LICENSING SUPPORT INFORMATION
FOR
PROPOSED CHANGES TO TECHNICAL SPECIFICATION
PRESSURE SWITCH TO ANALOG REPLACEMENT

BRUNSWICK STEAM ELECTRIC PLANT
UNIT NO. 1

LICENSING SUPPORT INFORMATION

PRESSURE SWITCH TO ANALOG REPLACEMENT

FIGURE 7-1

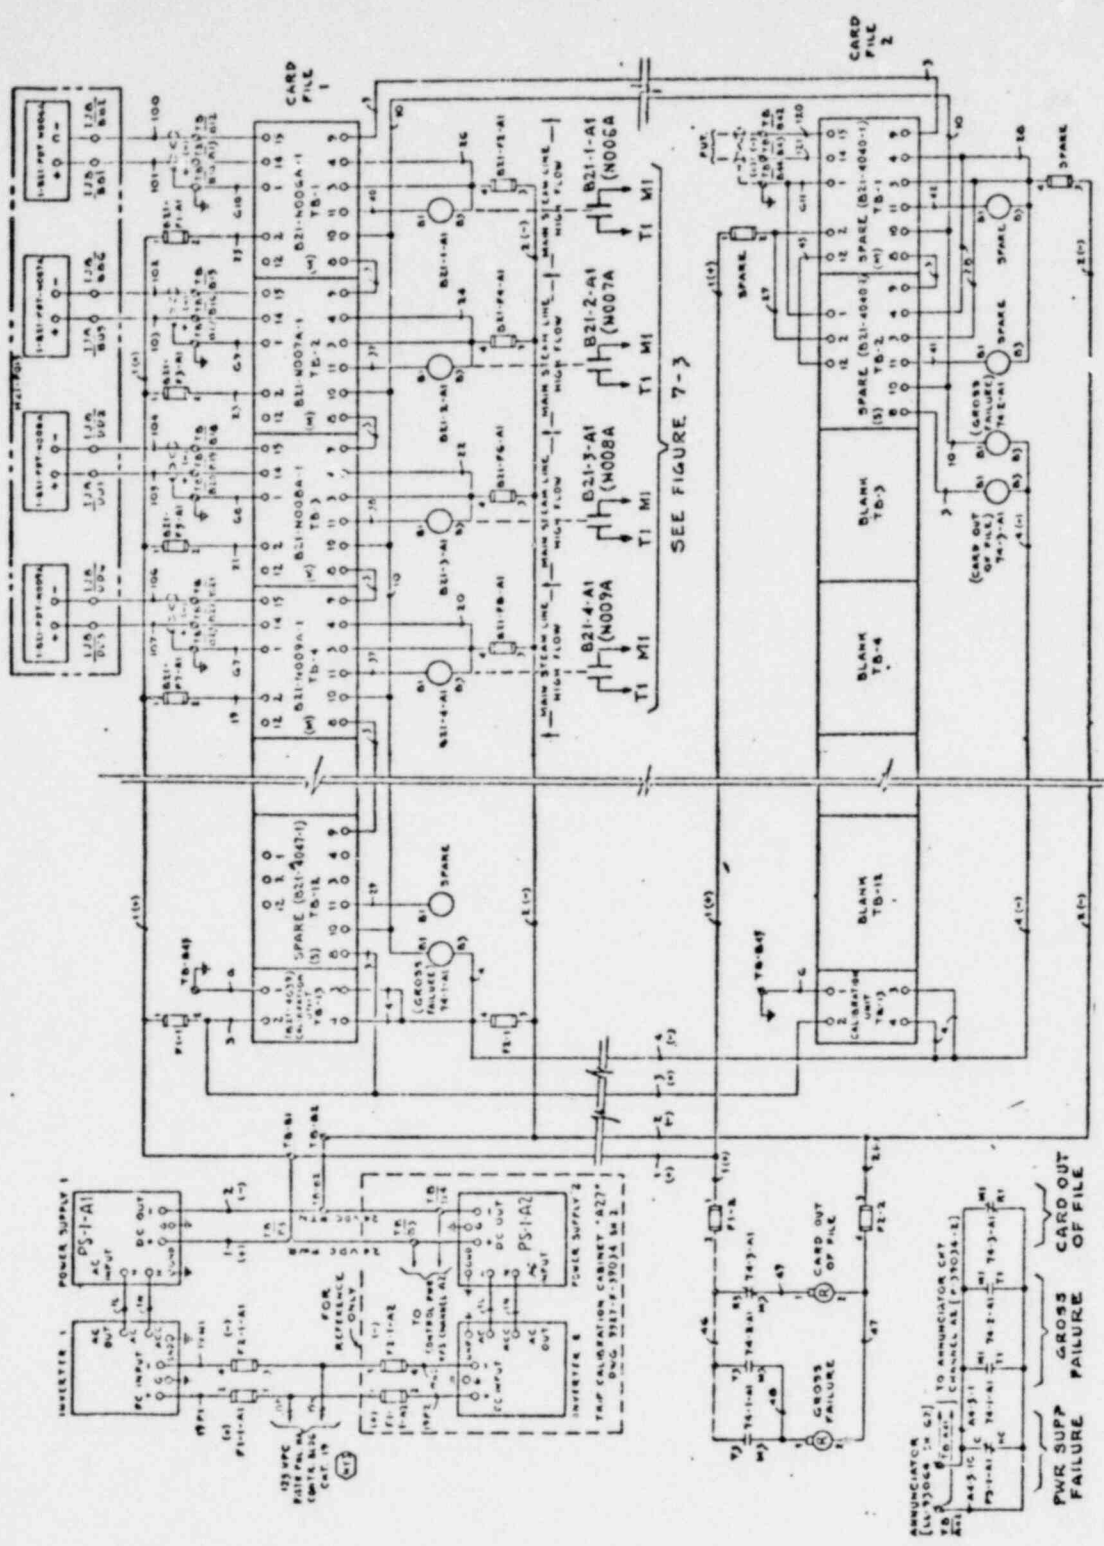
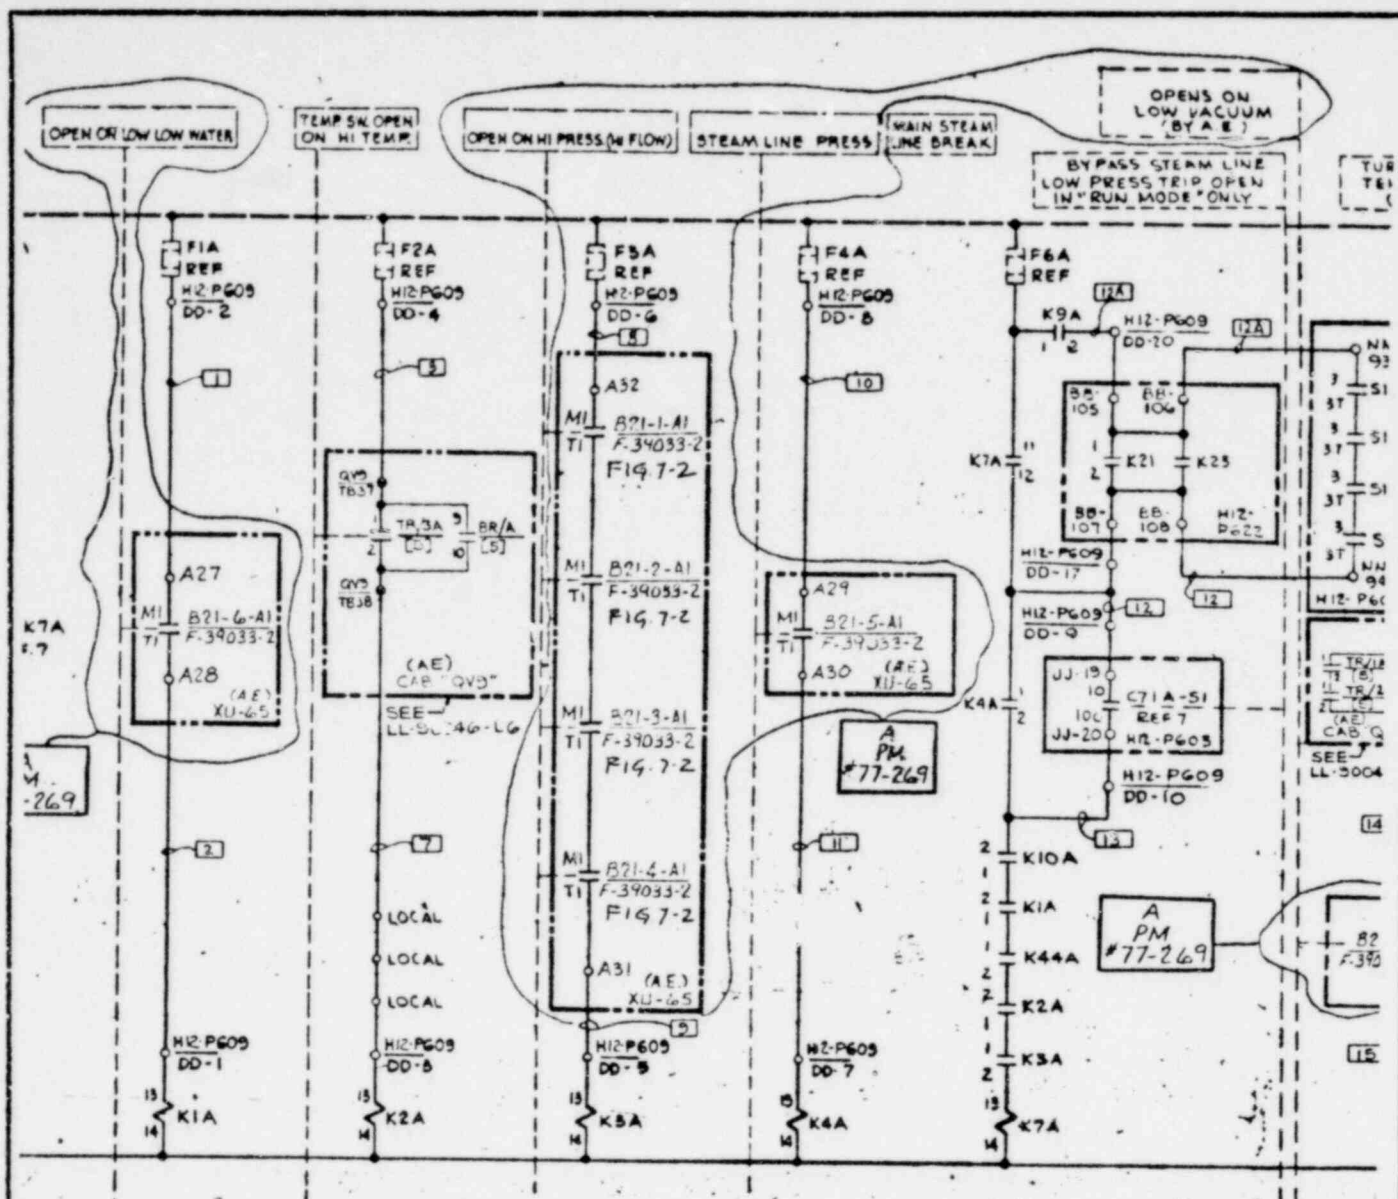
Refer to Figures 7-1, 7-2 and 7-3 which show changes introduced to the logic input circuit for specific loops B21-N006A, 7A, 8A and 9A.
